18 Fremont Street Hotel & Casino - update #1

CITY OF LAS VEGAS INTER-OFFICE MEMORANDUM			DATE: August 31, 2020
TO: Land Development Services Department of Building & Safety			FROM: Jennifer Shinn, P.E Flood Control Engr. Associate Department of Public Works
SUBJECT: Drainage Study for: 18 Fremont Street Hotel & Casino – Update #1			COPIES TO: Lochsa Engineering
Cross Streets:	NEC of Main St. and Fremont St.		18 Fremont Street Acquisition, LLC
File Number:	F:\Depot\DSMemos\DS4983C.doc		Bart Anderson, P.E., DevCo
Parcel Number:	139-34-112-001		
Zoning Action:	SDR-73004		
FEMA Flood Zone	YES	NO	X
Proposed Storm Drain	YES	X	NO

3rd Submittal: Update #2 to revise drop inlet connection in Main Street

Technical Drainage Study Update for 18 Fremont Street Hotel and Casino

Project Description	
Worksheet	Existing/Extended 36"RCP for the 30ft D.I. @
Flow Element	Circular Channel
Method	Manning's Formula
Solve For	Channel Depth

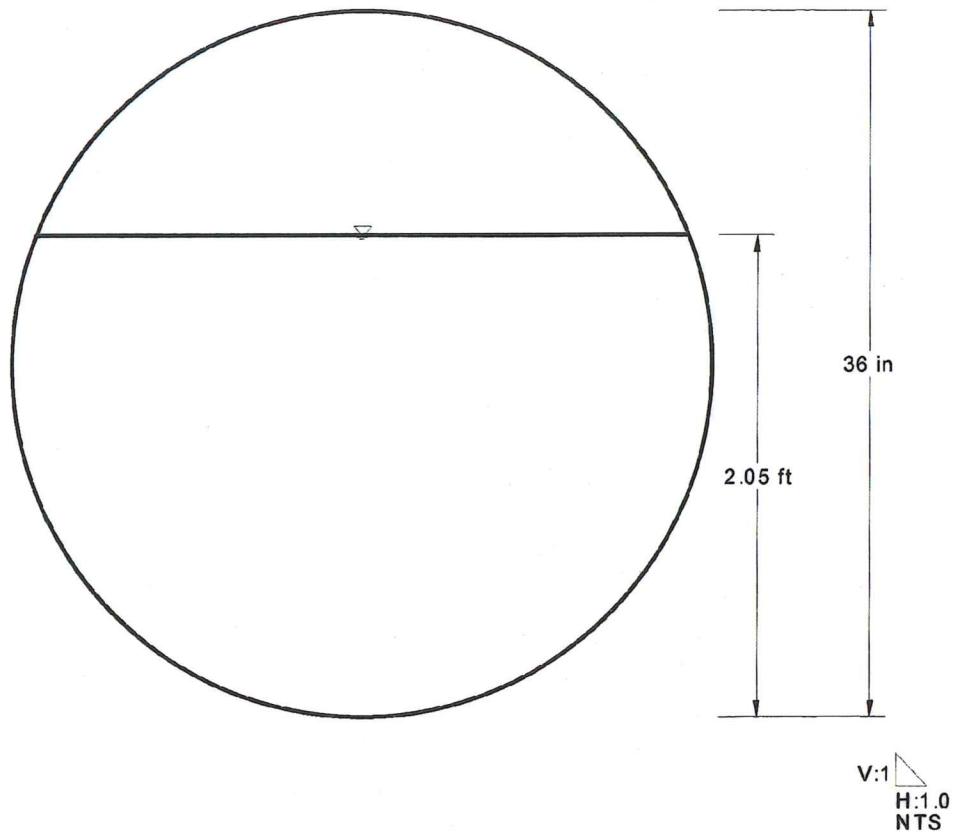
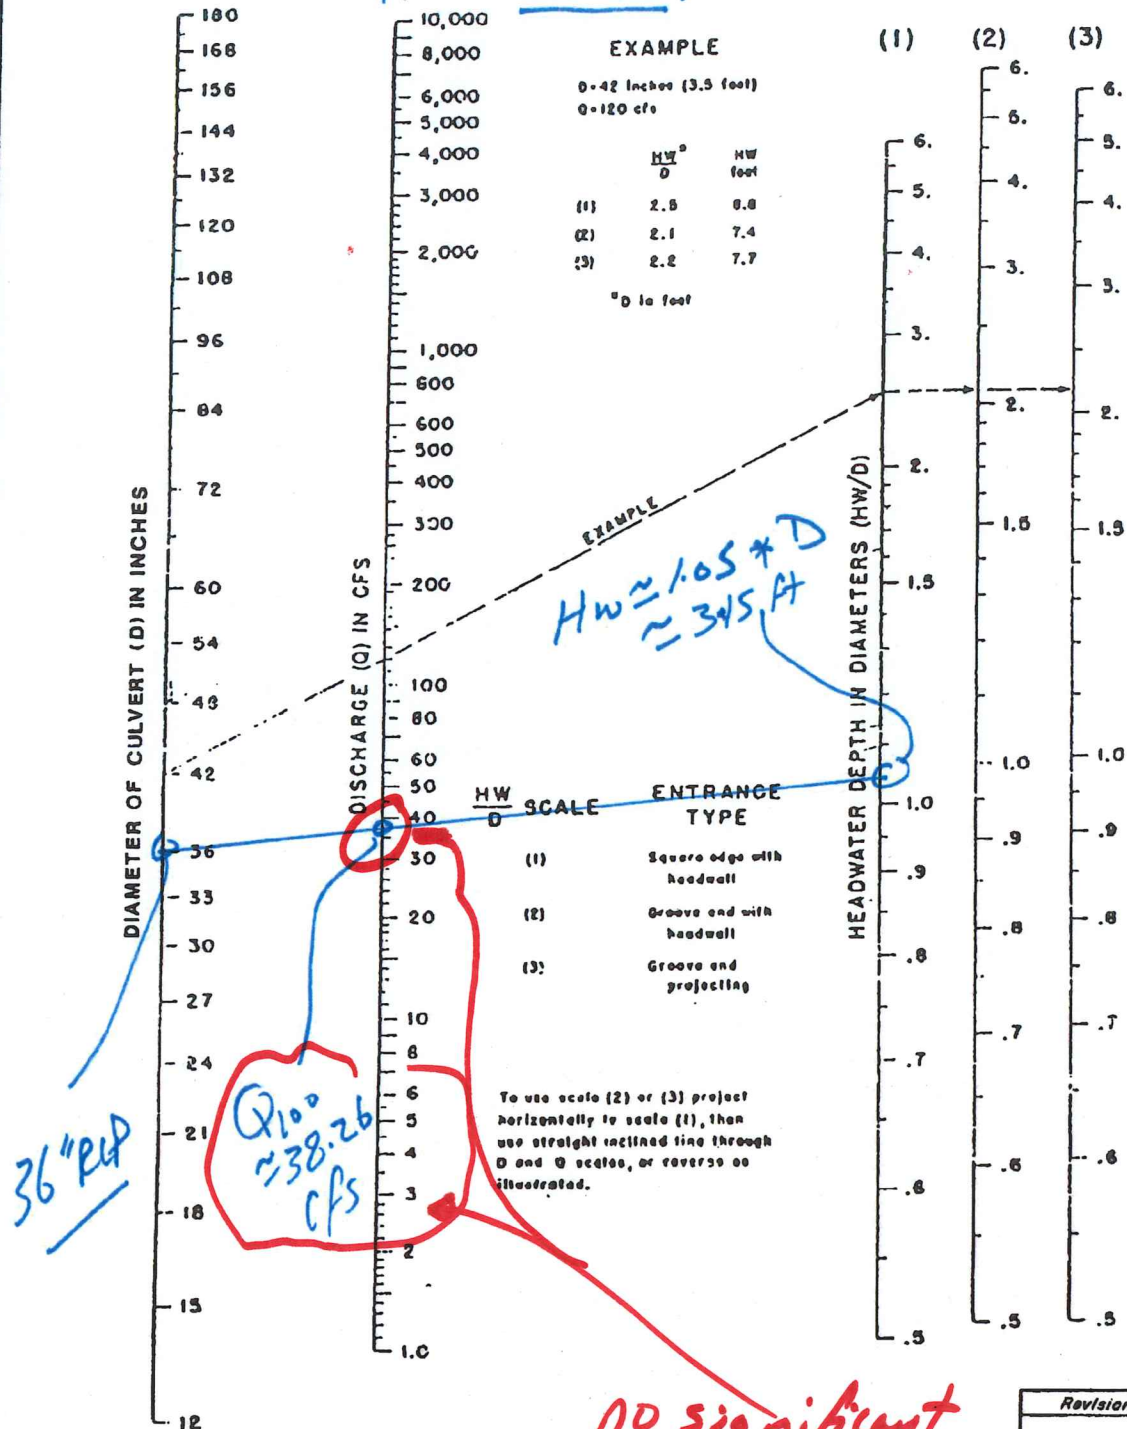
← Should now be
≈ 42 cfs

NO significant change for 42 cfs.

Project Description	
Worksheet	Existing/Extended 30"RCP for the 15ft D.I. @
Flow Element	Circular Channel
Method	Manning's Formula
Solve For	Channel Depth

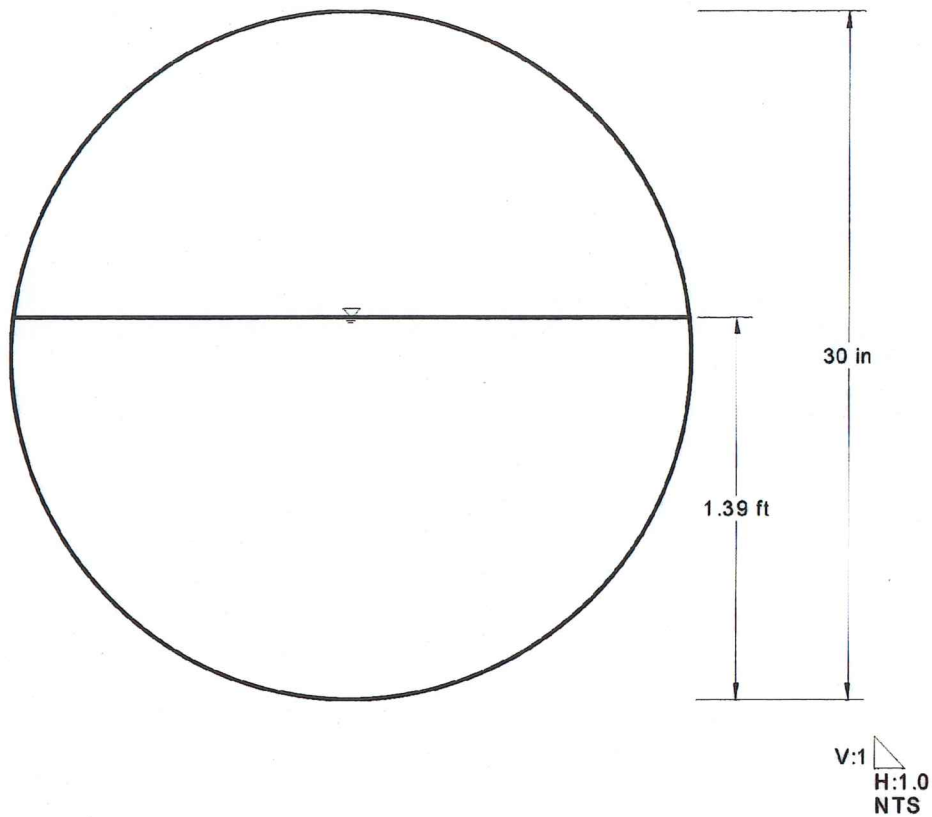
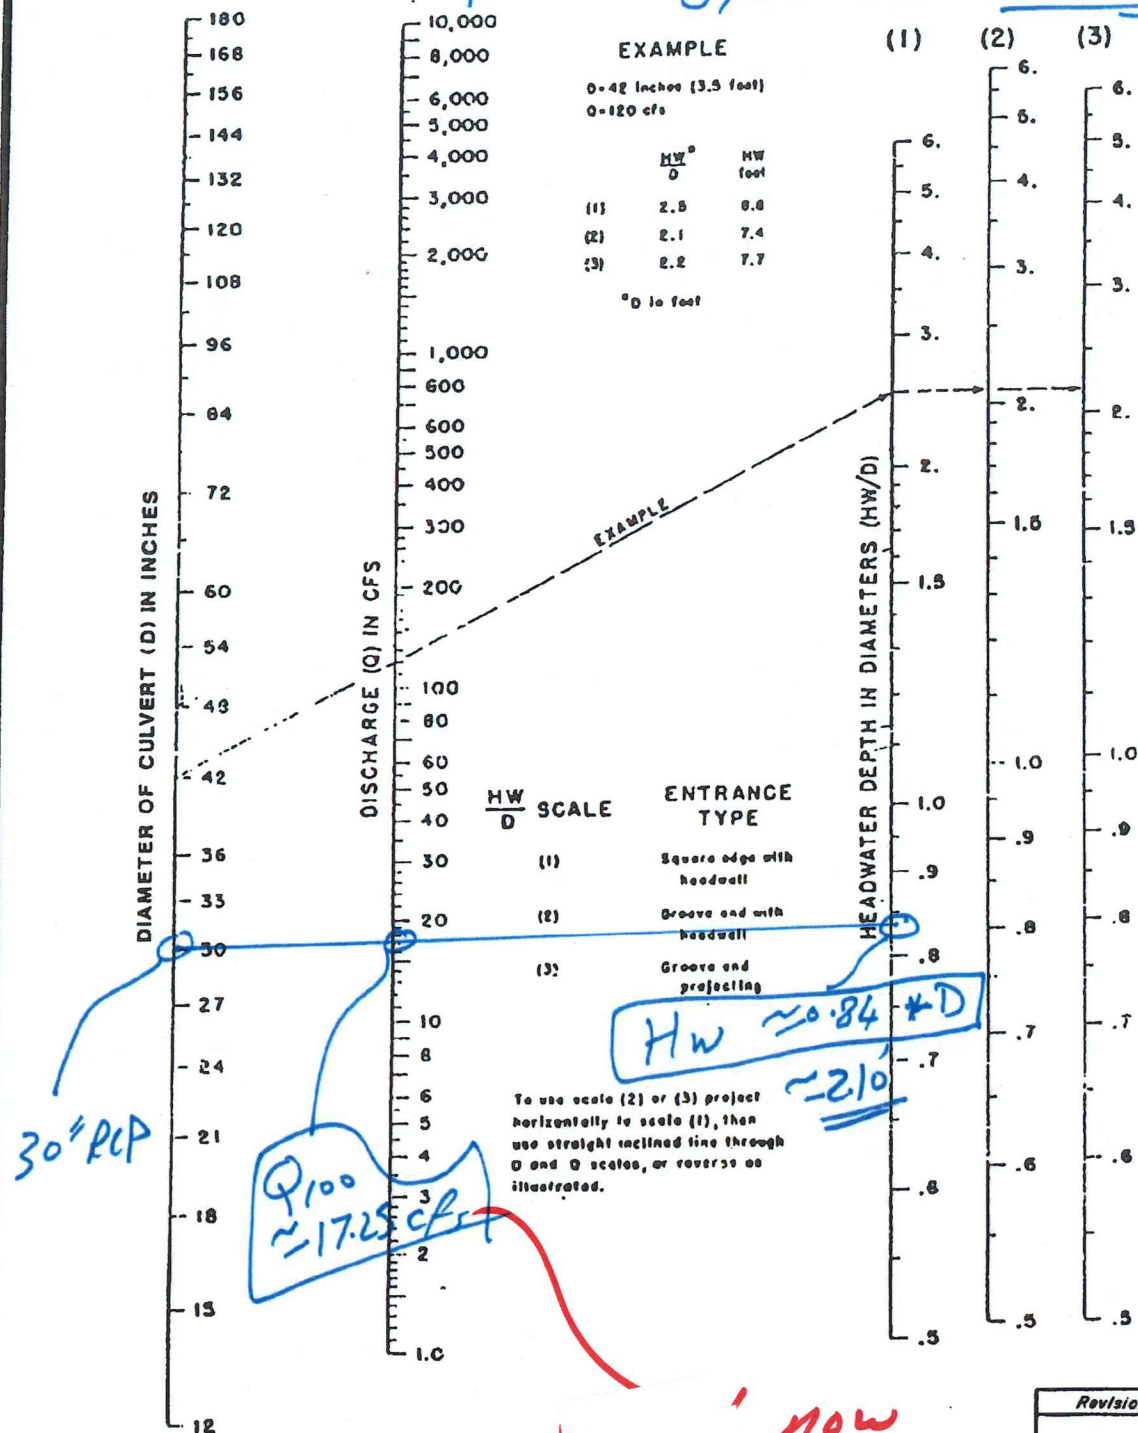
Now Reduced to
14 cfs

COVER SHEET

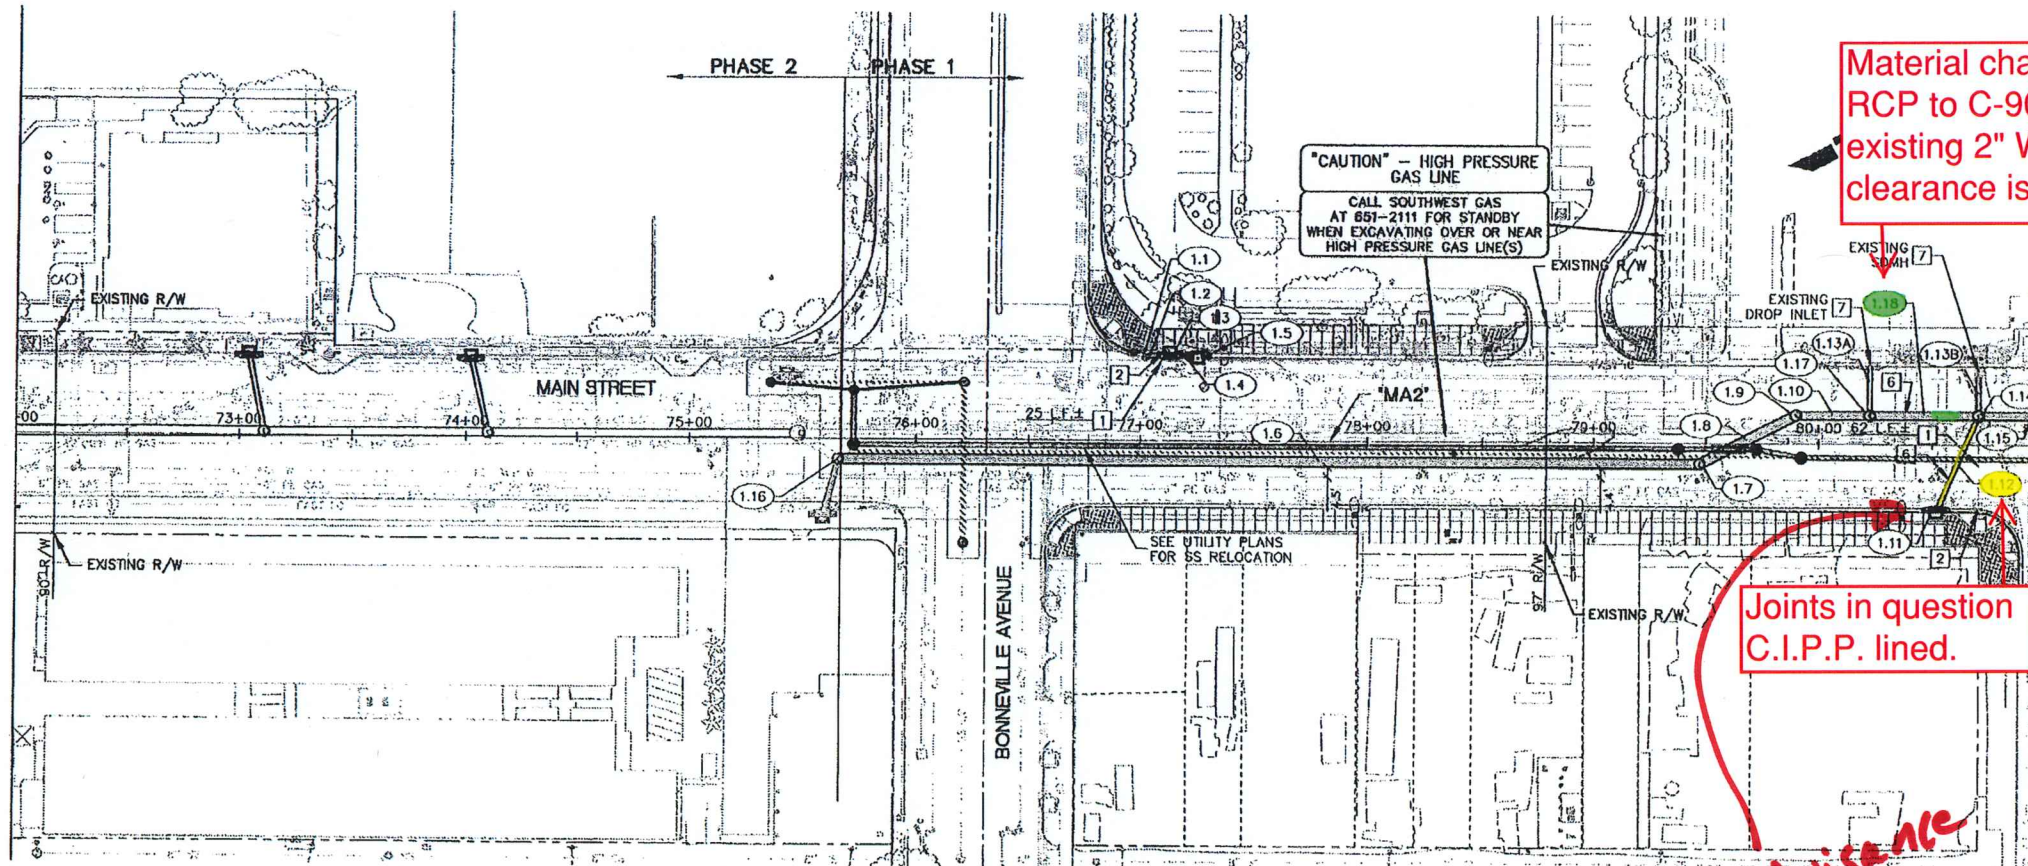
Material change from RCP to C-905 due to existing 2" W/L clearance issues.

MAIN STREET PHASE 1 IMPROVEMENTS
DRAINAGE PLAN
"MA2" 81+00.00 TO "MA2" 90+00.00
SHEET: D-2
48 of 115
DRAWING NO. 116660

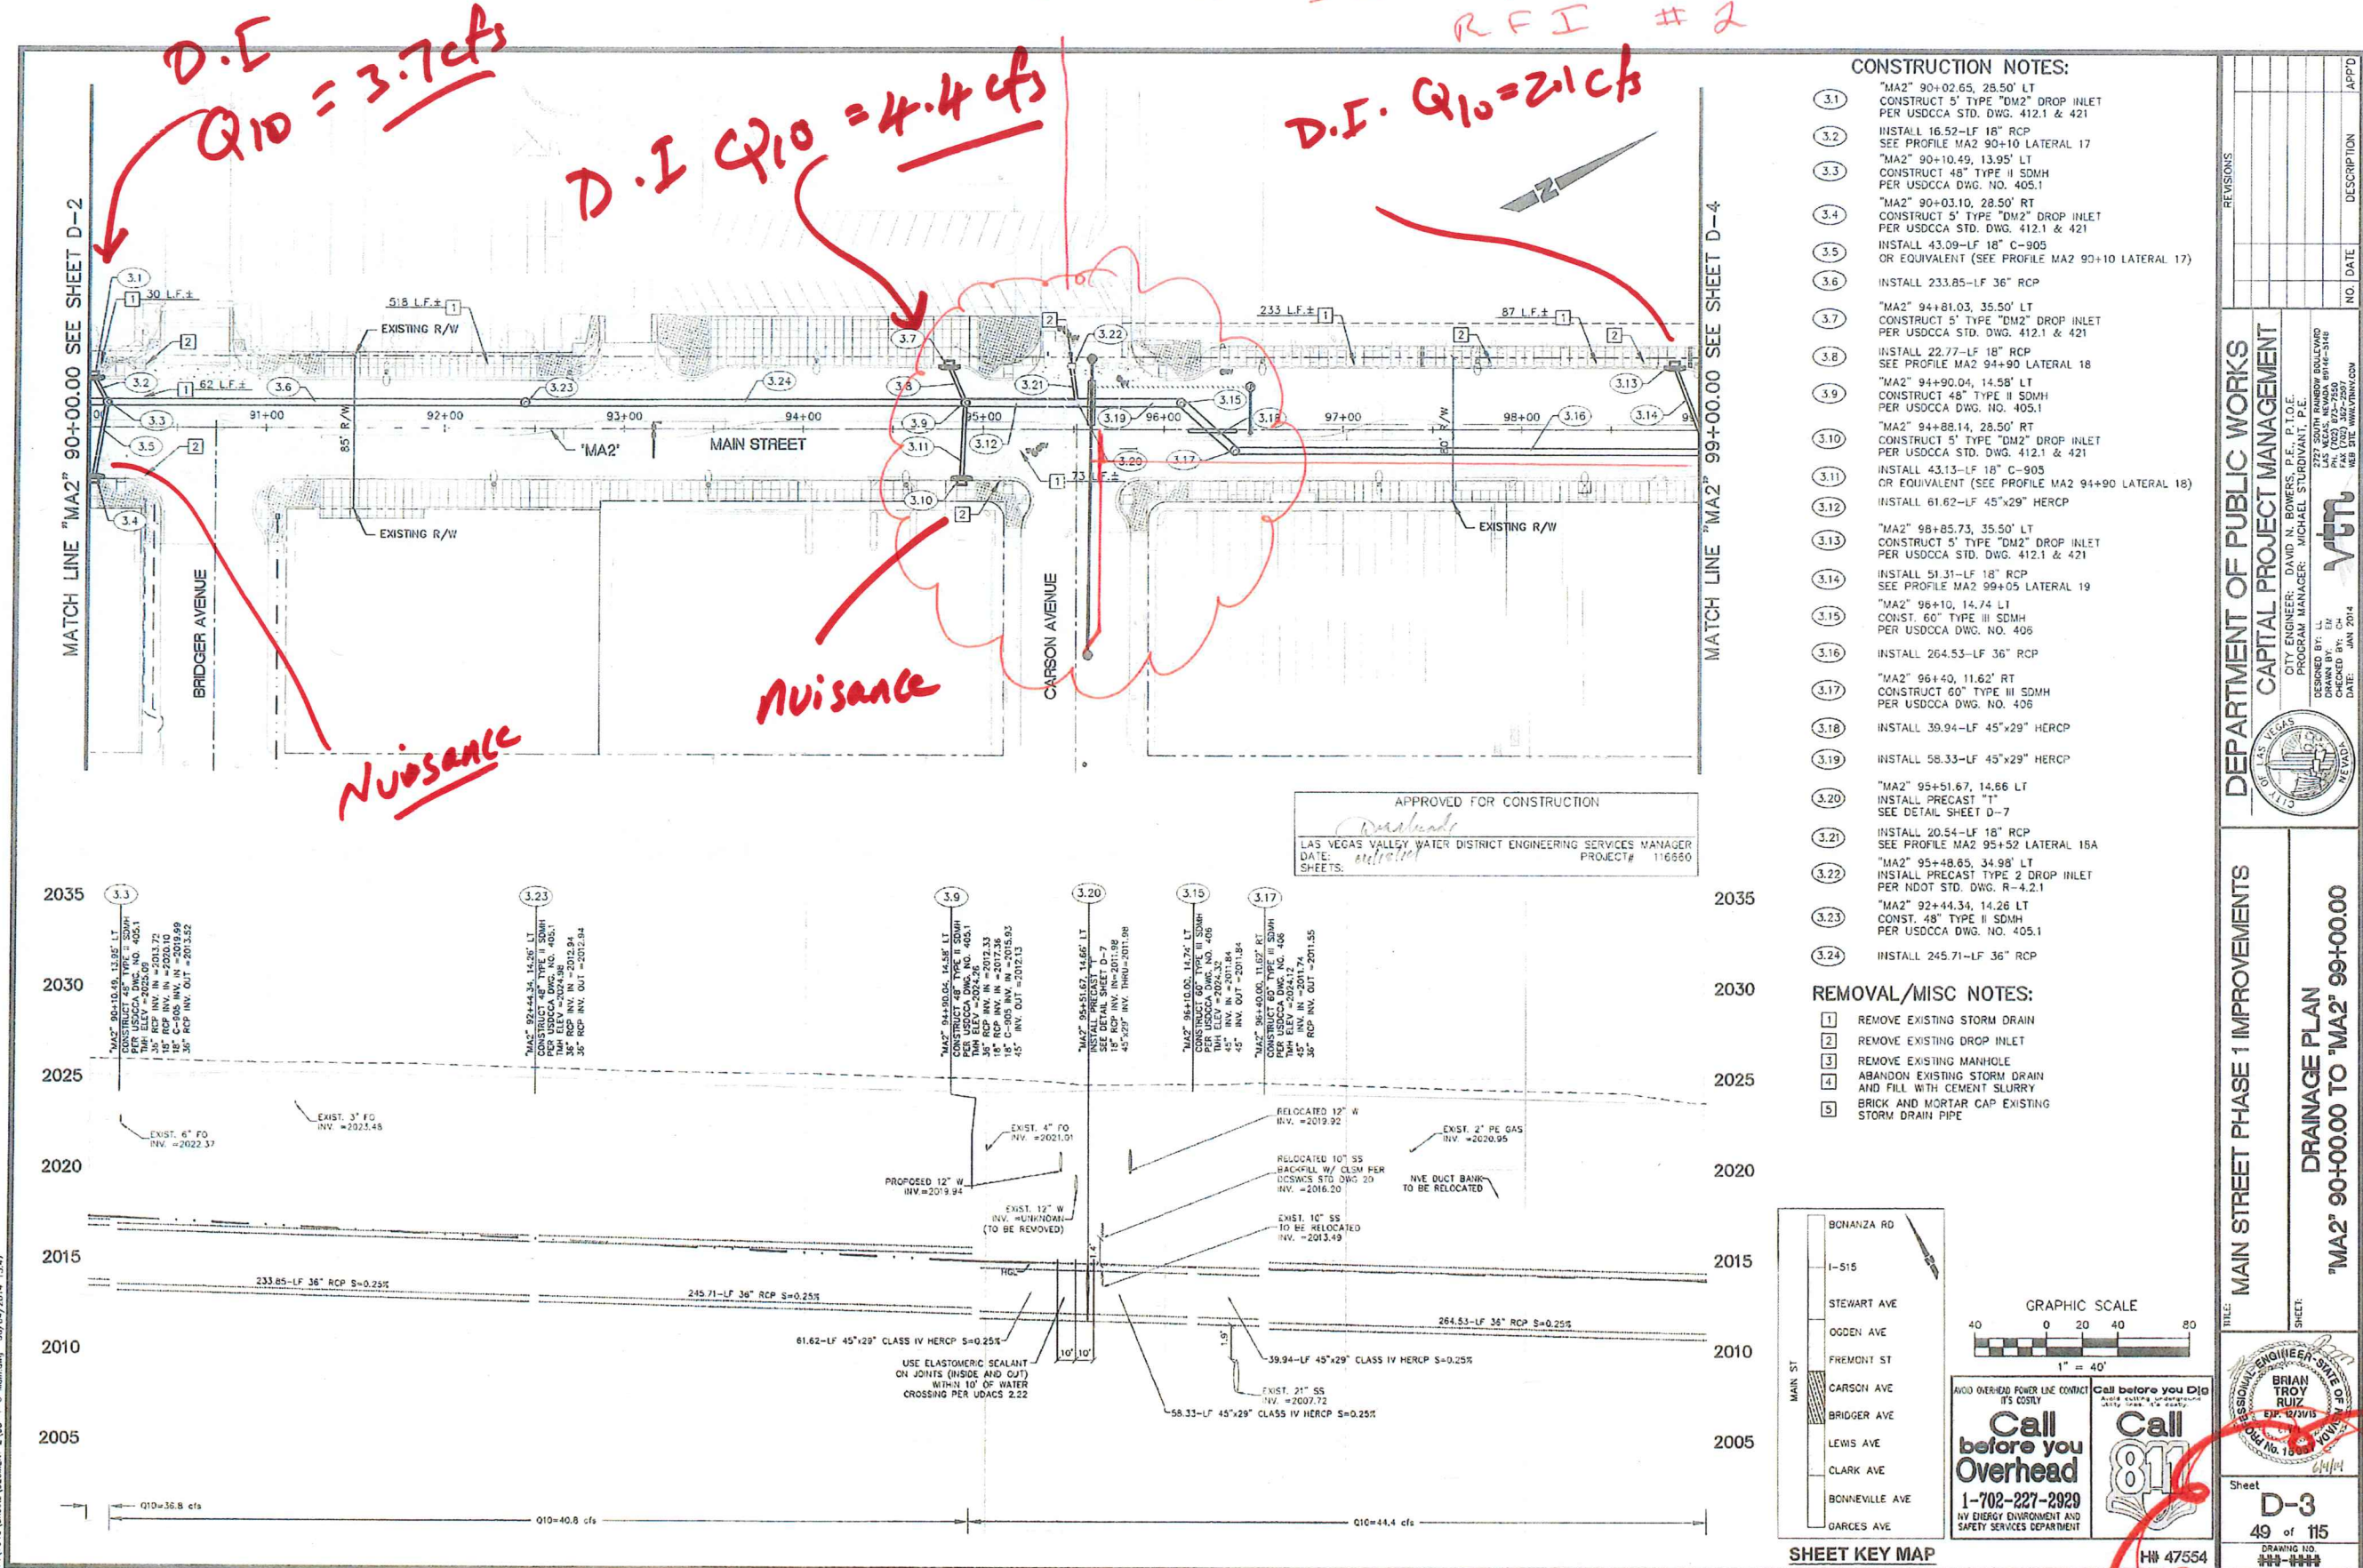
Carson's S/S & storm drain pipe locations have moved due to existing conflicts, check log for new locations.
RFI #2
